UNITED STATES PATENT AND TRADEMARK OFFICE

APPLICATION NO.	FILING DATE	FIRST NAMED INVENTOR	ATTORNEY DOCKET NO.	CONFIRMATION NO.
10/695,067	10/28/2003	J. Stewart Young	4002-3431	5993

Office Action Summary	Application No.	Applicant(s)	
	10/695,067	YOUNG ET AL.	
	Examiner	Art Unit	
	Jerry Cumberledge	3733

DETAILED ACTION

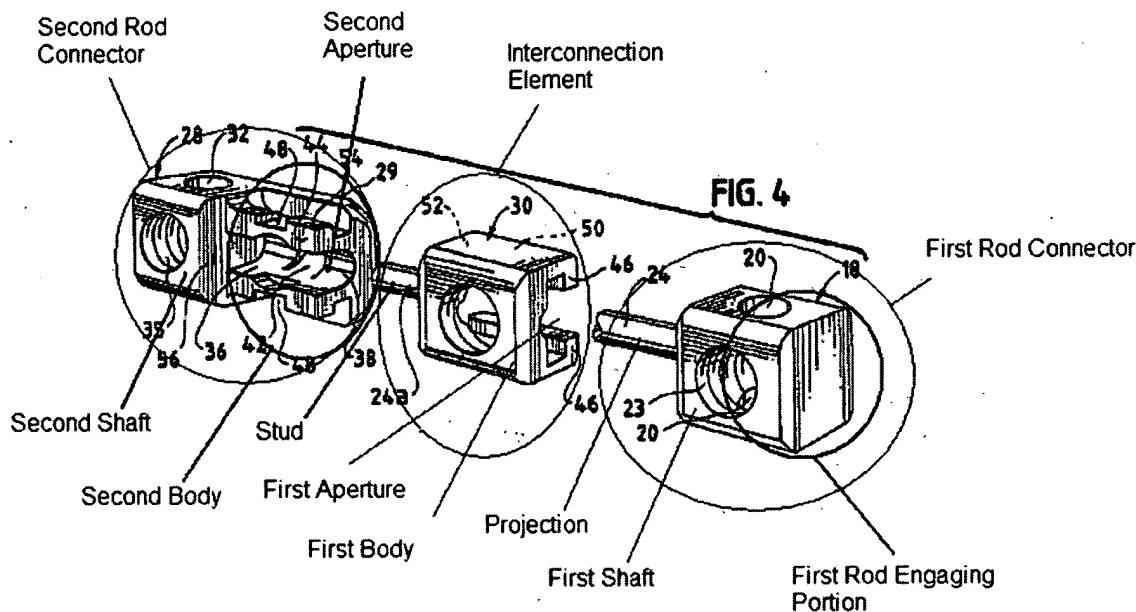
Korhonen et al. disclose a cross-connector assembly for interconnecting a pair of orthopedic rods (Fig. 4, below), said assembly comprising: an interconnection element including a first body having a first aperture formed therein and a stud extending from the body; a first rod connector including a first shaft terminating in a first rod engaging portion and a projection extending laterally from said first shaft and displaced axially along said first shaft from the spinal rod engaging portion, said first shaft and said projection slideably received within the first aperture; a second rod connector including a second shaft having a second body carried thereon, said second body having a second aperture formed therein, said second aperture having the stud received therein; and a fastener configured to engage with the stud (Fig. 2, ref. 34). The first aperture defines a first axis (Fig. 4, the axis that extends from near bottom ref. 46 to near top ref. 46, along the rectangular portion of the aperture) extending through the first body and the stud is positioned to lie substantially orthogonal to the axis (Fig. 4, below). The first aperture is non-circular, since it has a rectangular component (Fig. 4, near bottom ref. 46 to near top ref. 46). The first shaft exhibits a substantially round cross-sectional

profile (Fig. 4). The first rod connecting portion comprises a curved member configured to at least partially encircle a spinal rod, since the rod engaging portion has curves near ref. 20 and ref. 23, which can be used to encircle a spinal rod. The first rod connecting portion comprises a threaded aperture (Fig. 4, ref. 23) extending into the curved member. The first shaft is substantially straight (Fig. 4). The first shaft is curved so as to be non-linear, since it has rounded edges. The second shaft is curved, since it has rounded edges. The first shaft is slidable received within the first aperture to allow the first rod engaging portion to be spaced from the second rod engaging portion at varying distances. The second shaft is rotatable about an axis formed by the stud to vary an angle defined by the first shaft and the second shaft. The first shaft and the second shaft are curved, since they have rounded edges. The second aperture of the second shaft is configured to allow the second shaft to pivot along the axis defined by the stud. The first rod connector is rotatable about an axis defined by the first shaft. The second body on the second shaft includes a lower surface (Fig 4, surface near ref. 38), wherein engagement of the fastener to the stud urges the lower surface to contact the first shaft and clamp the fast shaft in a first orientation relative to the second shaft. The first rod connector is rotatable about an axis defined by the first shaft. Rotation of the first rod connector induces the projection to contact said first body and inhibit removal of the first shaft from the first aperture. The first rod connector is rotatable about an axis defined by the stud. The second rod connector is rotatable about an axis defined by the stud. The first shaft of the first rod connector and the second shaft of the second rod connector are curved, since they have rounded edges. The first shaft is slidable received within

the first aperture to allow the first rod engaging portion to be spaced from the second rod engaging portion at varying distances. The assembly further comprises a first spinal rod (Fig. 1, ref. 12) secured to the first rod engaging portion (Fig. 1) and a second spinal rod (Fig. 1, ref. 14) secured to the second rod engaging portion, wherein the first spinal rod is positioned to lie non-parallel to the second spinal rod. Engagement of the fastener to the stud induces the washer to deform. Engagement of the fastener frictionally engages the washer to the first shaft of the first rod connector. Engagement of the fastener to the stud secures the second rod connector in a selected orientation. The first spinal rod defines a first plane and the second spinal rod is positioned to lie in a plane different from the first plane. The first rod engaging portion comprises a hook sized to at least partially encircle a spinal rod, said hook extending laterally from the first shaft in a first direction and wherein said projection extends laterally from the first shaft along said first direction. The definition of hook, according to the Merriam-Webster Online Dictionary, is "a curved or bent device for catching, holding or pulling." The rod engaging portion can be considered to be a hook, because it has curves (around the circular bores), and it is used for holding the rod. It is extending laterally from the shaft, since it is coming from the side of the shaft (Fig. 4). The projection defines a finger, lobe, or ridge. The projection can be considered to be a finger. At least one of the first shaft or the second shaft has a smooth exterior surface (Fig. 4) and a round or oval cross-sectional profile (Fig. 4). The first and second shafts are configured to nest with each other (Fig. 2).

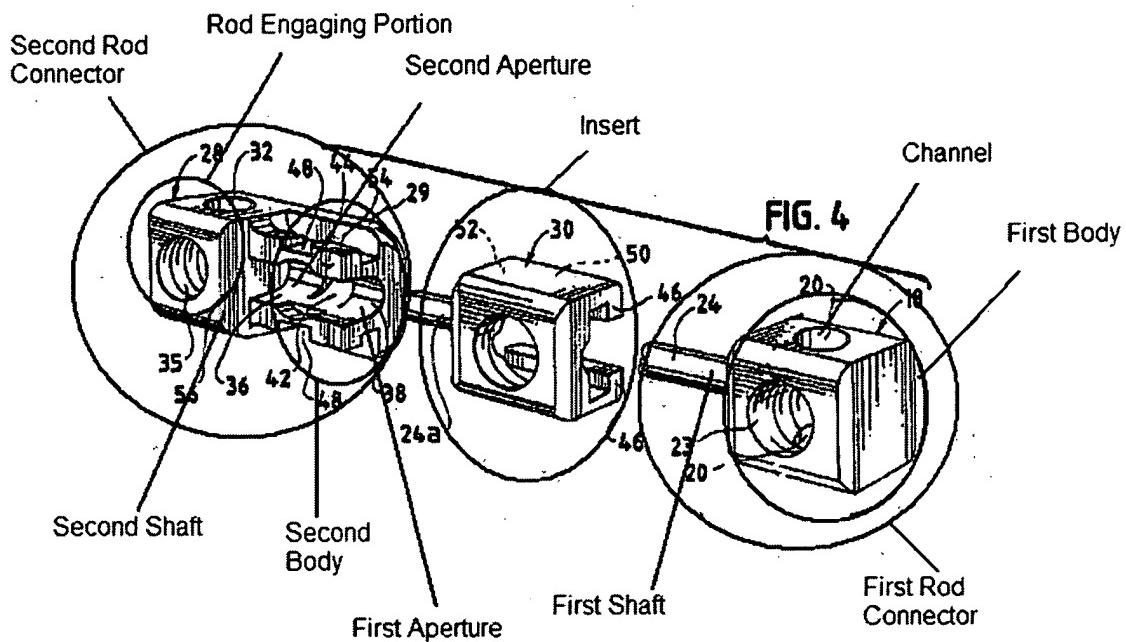
Korhonen et al. disclose a cross-connector assembly (Fig. 4, below) for interconnecting a pair of orthopedic rods, said assembly comprising: a first rod connector including a first shaft terminating in a first body having a channel therethrough a second rod connector including a second shaft defining a longitudinal axis and terminating on a first end with a rod engaging portion and on an opposite second end with a second body, said second body having a first aperture therein defining a first central axis positioned to lie in a plane with the longitudinal axis, said

second rod connector also including a second aperture therein defining a second central axis positioned to lie at an angle to the first central axis; an insert configured to engage the first shaft of the first rod connecting member extending through the first aperture and positioned in said second body and in communication with said second aperture; and a fastener (Fig. 2, ref. 41) extending through the second aperture of the second body and engaging one or more of the insert (Fig. 2, ref. 41), the second body of the second rod connector, or the first shaft of the first rod to secure the orientation of the first rod connector relative to the second rod connector. The first shaft of the first connector is straight (Fig. 4). The first shaft of the first connector is curved, since it has rounded edges (Fig. 4). The first aperture and the second aperture intersect (Fig. 4). The fastener engages with both the insert and the first shaft. The fastener engages the insert thereby securing the first rod connecting member in a desired orientation relative to the second rod connecting member. The fastener engages the first shaft thereby securing the first rod connecting member in a desired orientation relative to the second rod connecting member. The fastener engages the second body of the second rod connector thereby securing the first rod connecting member in a desired orientation relative to the second rod connecting member.

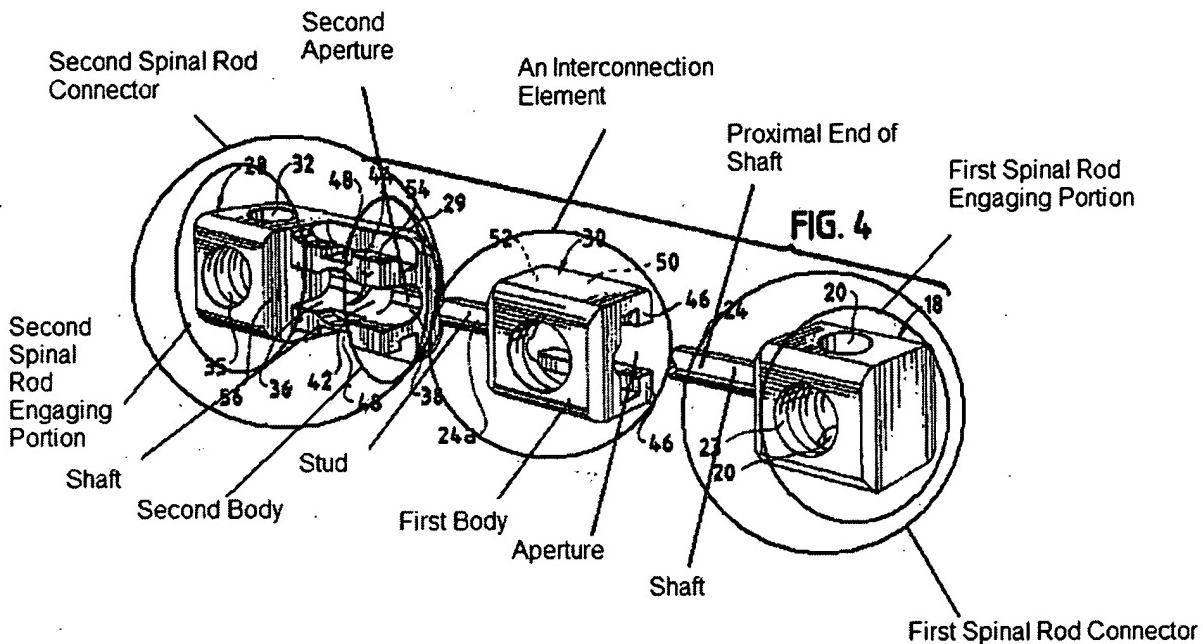
Korhonen et al. disclose an cross connector (Fig. 4, below) comprising an interconnection element including a first body having an aperture formed therein and a stud extending from said body; a first spinal rod connector including a first shaft having a proximal end received within said aperture and a distal end carrying a first spinal rod engaging portion configured to at least partially encircle a spinal rod; a second spinal rod connector having a second body on a proximal end, a second spinal rod engaging portion on a distal end and a second shaft extending therebetween , wherein said body includes a second aperture having the stud received therein; and a single fastener (Fig. 2, ref. 41) to secure the first and second spinal rod connectors to each other at a user defined orientation relative to each other.
